Office Action Summary

09/687,600

TRIPARD, JASON E.

DETAILED ACTION

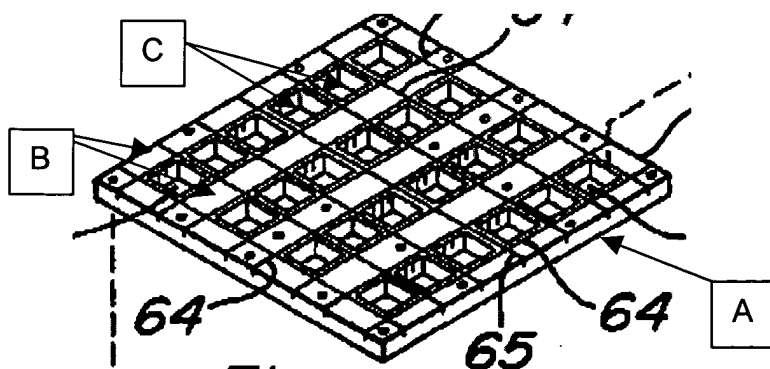
- a) a panel having an uppermost surface and molded as part of the separator (A, Figure below);
- b) a plurality of blocks (B, Figure below) as one piece with the panel and extending upward from the uppermost surface of the panel creating a recessed portion (C, Figure below) on the panel;
- c) a cutting mechanism.

The examiner respectfully disagrees. The figure above shows "a plurality of blocks" being formed as one piece with "a panel". The element A indicating a bottom portion of element 62 is designated as "a panel" wherein the element B designated as "a plurality of blocks" which extend upward from the uppermost surface of the element A. Hence, the recessed portion designated as the element C is formed by the element

B such that the recessed portion extend between the block upper surfaces (top surfaces of the element B) and the uppermost surface of the panel A.
